GOVERNMENT OF THE DISTRICT OF COLUMBIA  
DEPARTMENT OF TRANSPORTATION

**MEMORANDUM**

**SUBJECT:** **BZA Case No. 19626** – 2410 Market Street NE

Figure 2. Drive-Thru Queue (Source: Grove/Slade CTR, 10/3/2017, Figure 4)

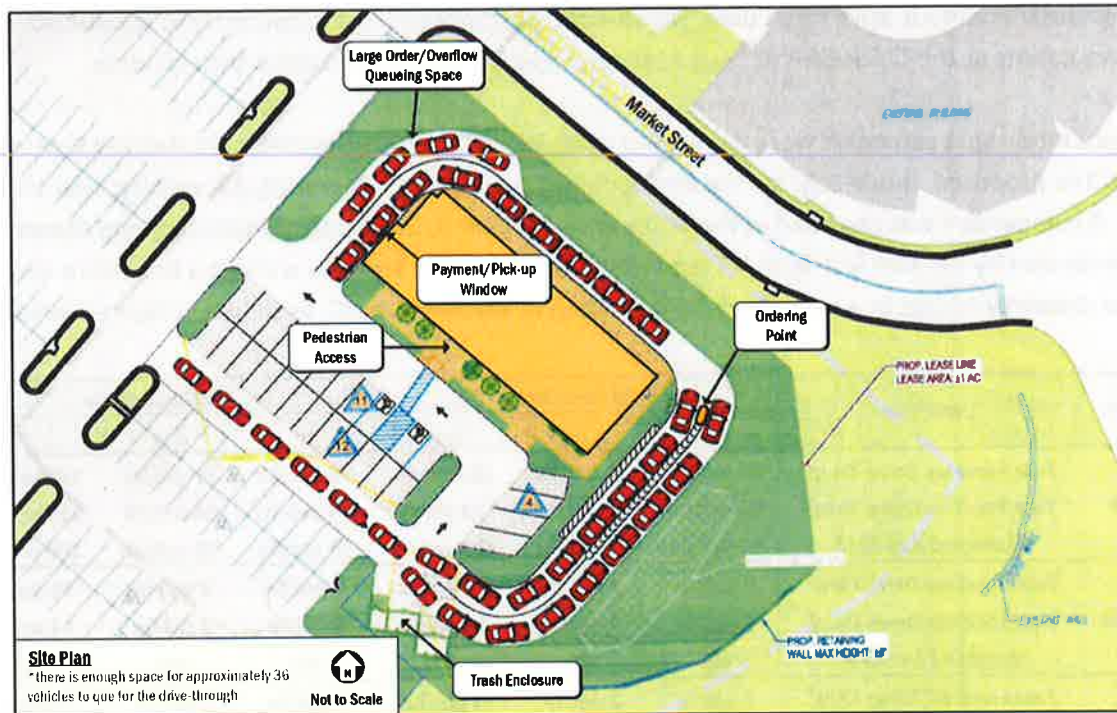
The proposed drive-thru will include a double-ordering queue with space for 36 vehicles as shown in Figure 2. This design was based on maximum queuing observations at five (5) Chick-Fil-A restaurants with drive-thru windows throughout the East Coast.

DDOT finds that there is sufficient queuing space on-site to prevent traffic from spilling back into privately maintained Market Street NE or further queuing into the public street network (e.g., New York Avenue, Fort Lincoln Drive, and 33rd Place NE).
